AUSTRALIAN PARACHUTE FEDERATION

APF SERVICE BULLETIN N^o. APF 100427 Issued 27 APRIL 2010

SUBJECT: RIPCORDER PIN TEST

Pic 1. Broken pin shown over "0" grommet

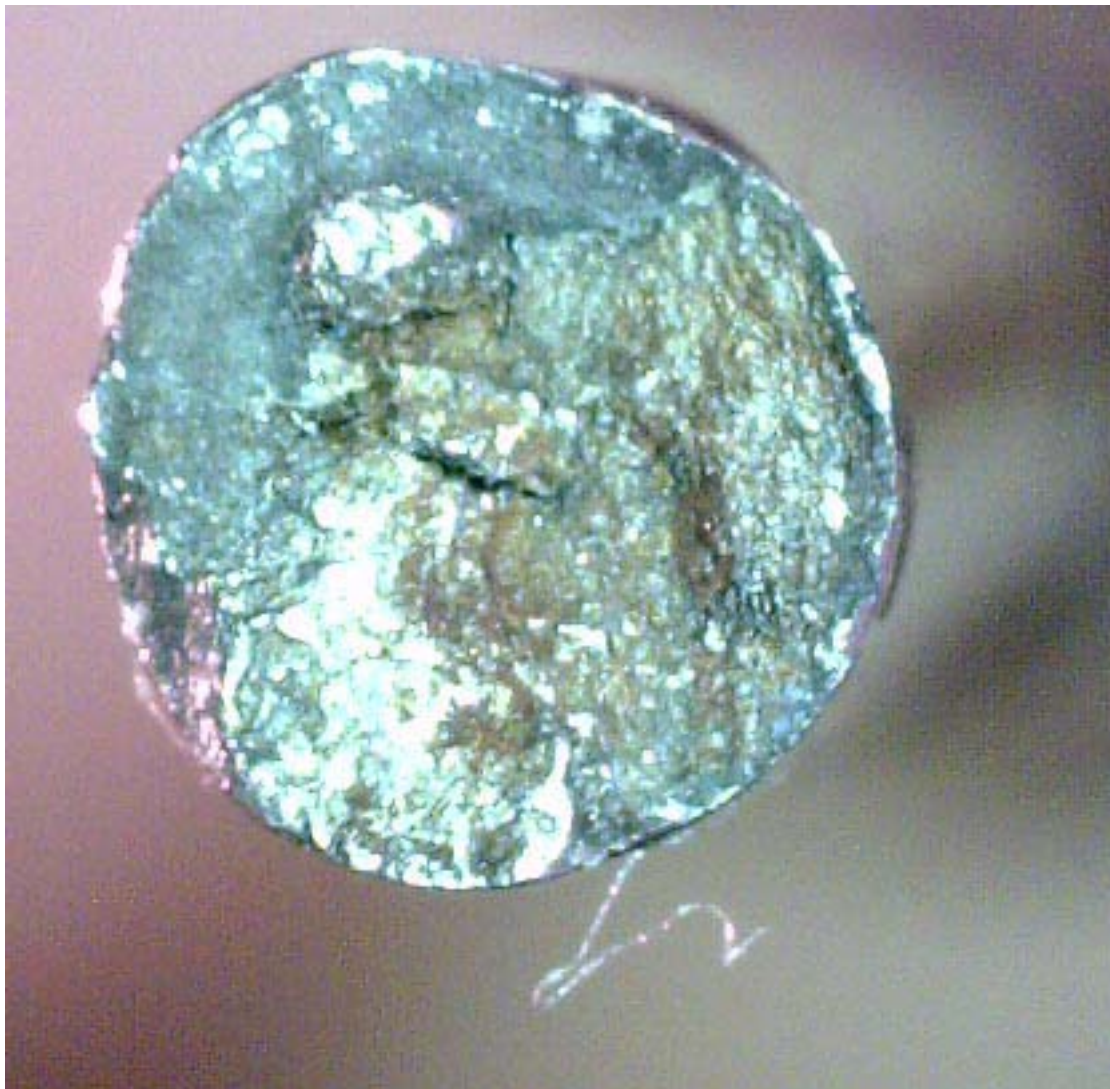
BACKGROUND: A reserve being closed after repack had the terminal pin of the ripcorder break as it was inserted into the closing loop. The rigger had closely inspected the pin prior to attempting to insert it and it was straight without any visible defect. The pin fractured 0.40" (10mm) from the shoulder at the place where the CYPRES closing loop would sit. The rig, a PA Talon was manufactured in 07/ 96 and the ripcorder was unmarked and presumed to be original as no other data was available on the log card to indicate otherwise. The ripcorder is outside the date period as noted in [Capewell SB No. CW03-01](#) and there are no indications that it may have been previously tested.

The location of the break is such that if it had been tested according to [Capewell SB CW03-01](#) test 2 it may have passed the test as the fulcrum point in this test is 0.188 from the shoulder and is above the break. Test 1, an in the field in situ test on a packed rig would be an appropriate test as the load would be applied at a point consistent with the seating of the closing loop.

APF ADVISORY: That all reserve ripcords in rigs manufactured before July 2003 that do not have manufacturer's data or test indications on them be subjected to [Capewell Service Bulletin CW03-01](#) **Field Test 1** and marked as indicated in the SB.

As test 2 may not be an adequate test due to the fulcrum point being too close to the shoulder an alternate test as described in Poynter's "the Parachute Manual" Vol. 2, Chapter 6.15. Inspection and Testing, where the pin tip is inserted ½" (12.5mm) into the test block and a load of 8lb is applied at right angles in four equispaced directions. This will test a greater length of the pin blade. The ripcord handle should then be permanently marked "APF-T2". The log card should also be annotated with the date and APF SB No.100427- T2.
